Addendum #1

Bid #10-17

Market Street Gateway Improvements, Phase 1

Issued on September 23, 2016

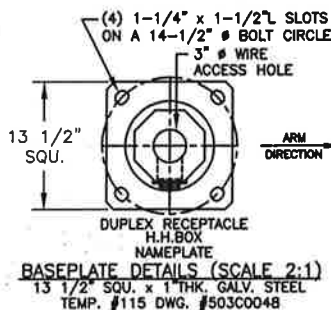
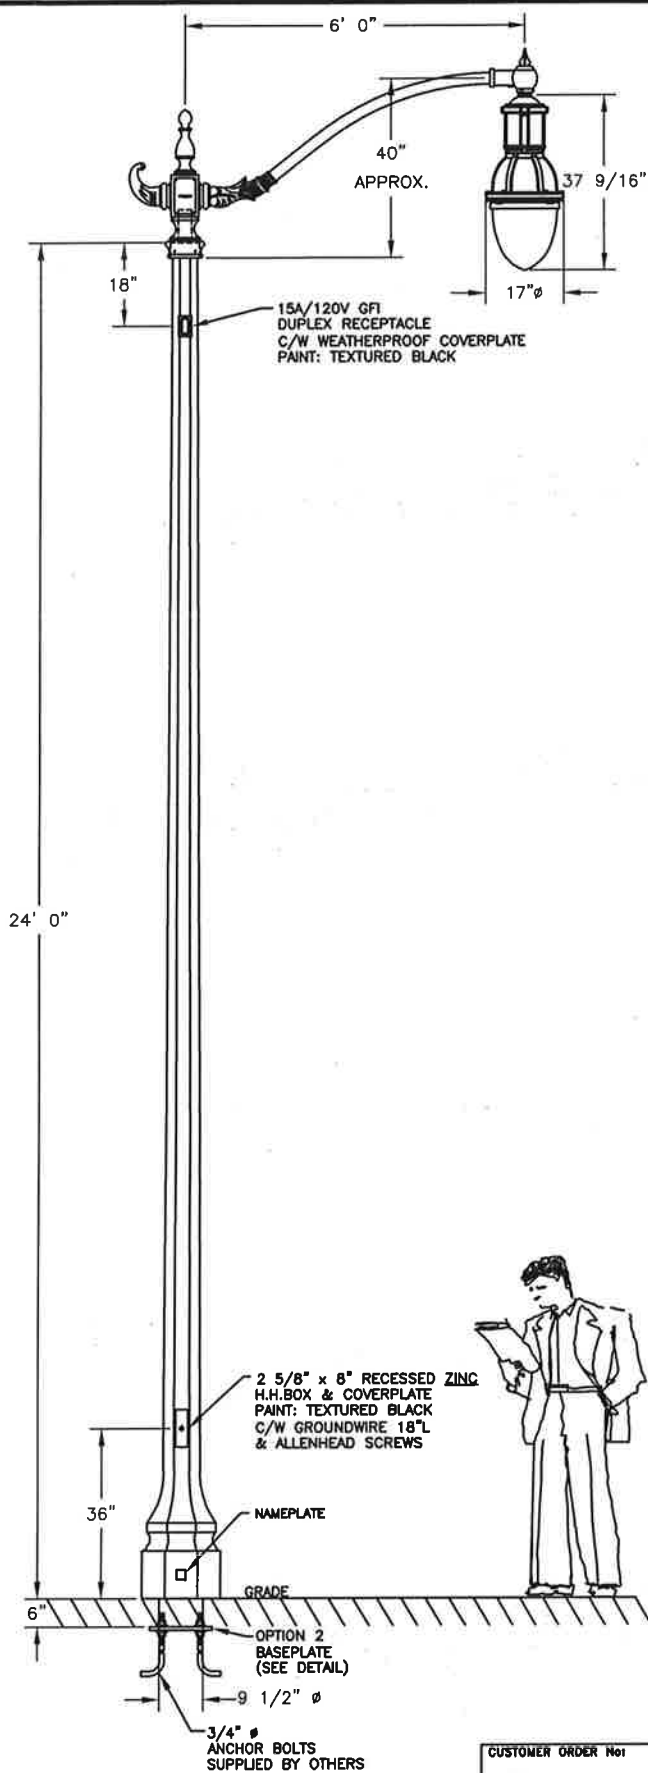
Bid Item # 665 street lights. The specifications indicate a 25' pole height where the bid sheet lists 24' please clarify.

The specified pole is a 24' high "Belmont" style pole with 6' arm as manufactured by Stresscrete with K833 Solitaire LED luminaire as manufactured by King Lighting. Cut sheets for the two different styles are attached in this addendum for clarity.
